Addendum 134 – UN Regulation No. 135

Amendment 2

Supplement 2 to the original version of the Regulation – Date of entry into force: 29 May 2020

Uniform provisions concerning the approval of vehicles with regard to their Pole Side Impact performance (PSI)

Figure

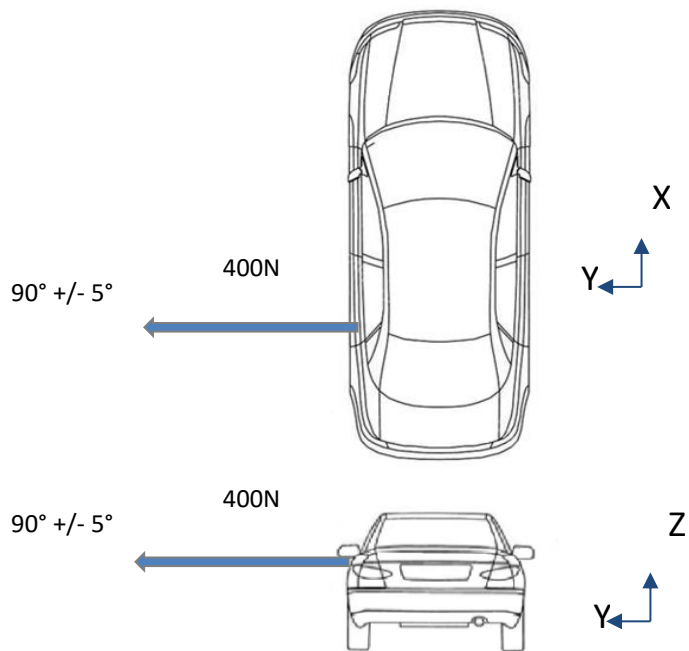
Paragraph 5.4.2.1, amend to read:

"5.4.2.1. The door shall remain latched;

This requirement is deemed to be fulfilled:

- (a) If it is clearly visible, that the door lock is latched; or
- (b) If the door does not open under a static tractive force of at least 400 N in the y-direction applied to the door, according to the Figure below, as close as possible to the window sill and to the edge of the door opposite to the hinged side, except to the door handle itself.
